**ITEM 7. DEVELOPMENT APPLICATION: 18-20 O'DEA AVENUE
WATERLOO****FILE NO: D/2014/1837****DEVELOPMENT APPLICATION NO: D/2014/1837****SUMMARY**

Date of Submission: 1 December 2014
Final amended plans received 26 May 2015

Applicant: Crown W1 Developments Pty Ltd

Proposal Summary: The Stage 2 DA proposes construction of a mixed use development comprising four residential flat buildings ranging in height from 8 to 21 storeys with a total of 331 apartments, two ground floor retail premises, landscaping, communal facilities, public domain and infrastructure works. The application also involves construction of Hatter Lane, the final portion of Dunkerley Place, the final portion of the Rope Walk Park and a setback from O'Dea Avenue for road widening / landscaping.

Figure 32: Extract from ground floor plan and level 7 demonstrating separation issues to be addressed by conditions of consent.

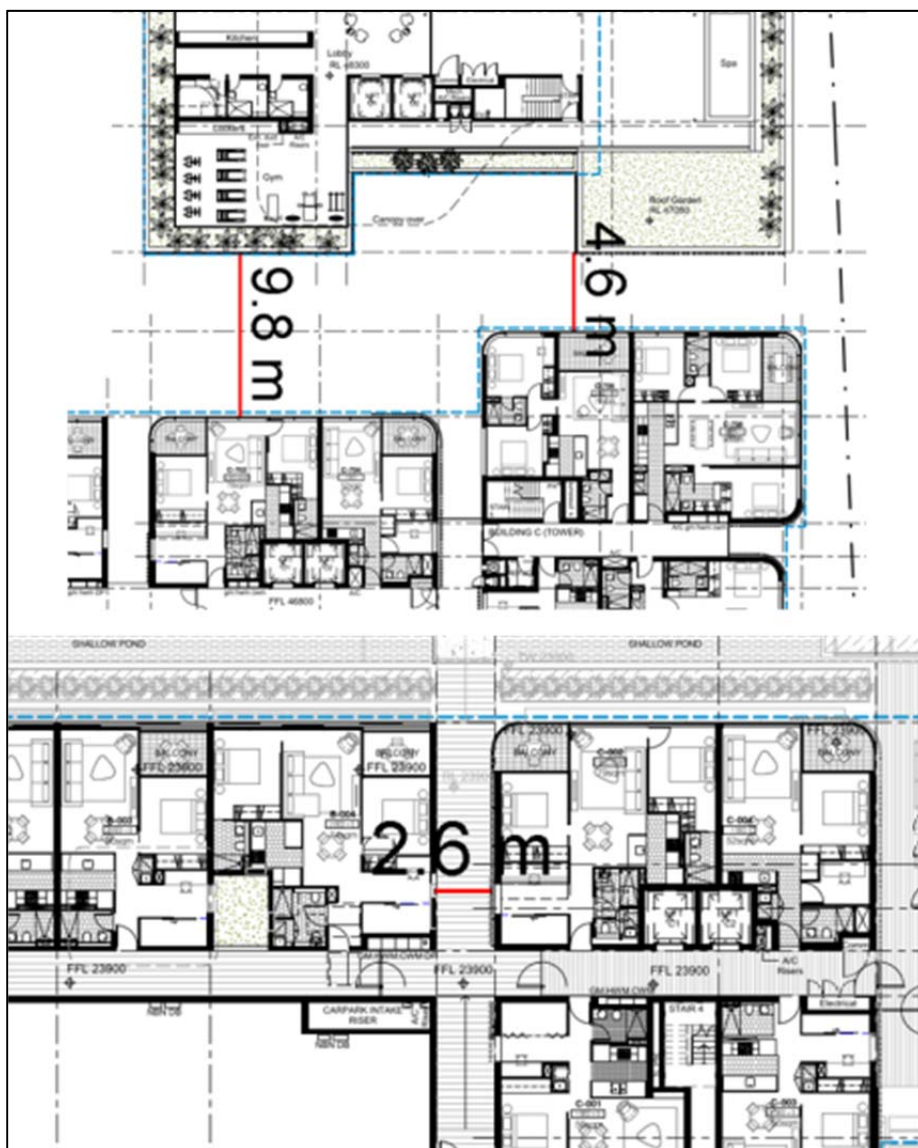
105. Insufficient separation to provide adequate acoustic and visual separation has been provided between a number of studies and communal areas as shown in Figure 32. In most instances study windows are provided less than 3 metres from an adjoining apartment window. In these instances it is recommended that these windows be removed.

Figure 34: Extract from ground floor plan identifying pinch points and access arrangements

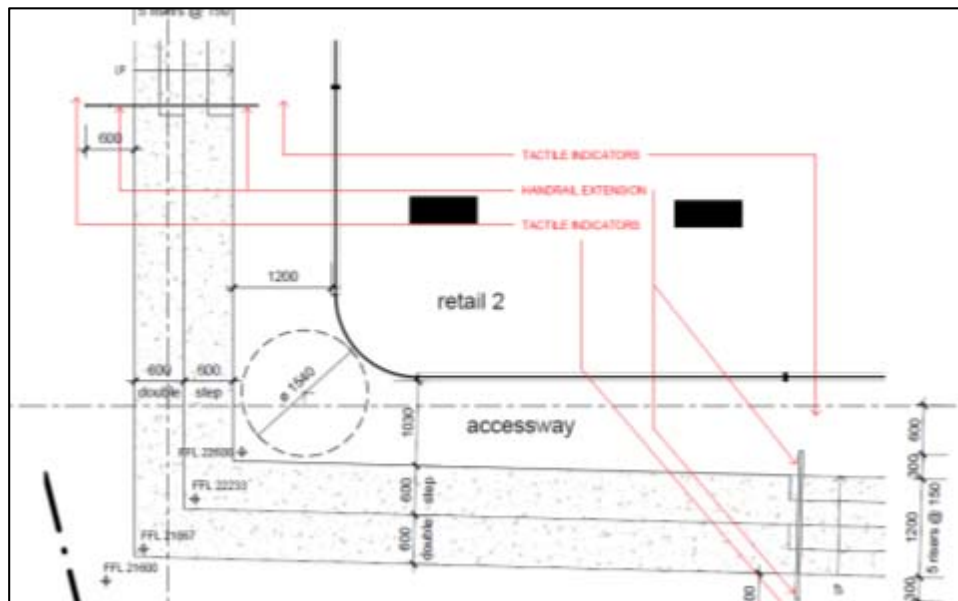
120. An accessible access point is provided to each entrance of the buildings and to the ground floor non-residential tenancies. Concern is raised with a pinch point at the south east corner of the site fronting the new Rope Walk Park between 1m and 1.2m as shown in Figure 34 below.

121. The applicant has stated that a minimum of 1.5 metres at the corner will be provided which is sufficient to satisfy the BCA for two people to pass each other. Notwithstanding the technical compliance at this particular point, it would be impractical for two persons in wheelchairs or with prams to pass each other at this point, one person may need to either enter the non-residential tenancy or reverse back down the long ramp.
122. To resolve this issue it is recommended that the glazing of the non-residential tenancies be set back to allow two clear metres along the eastern frontage to allow practical circulation within this space.
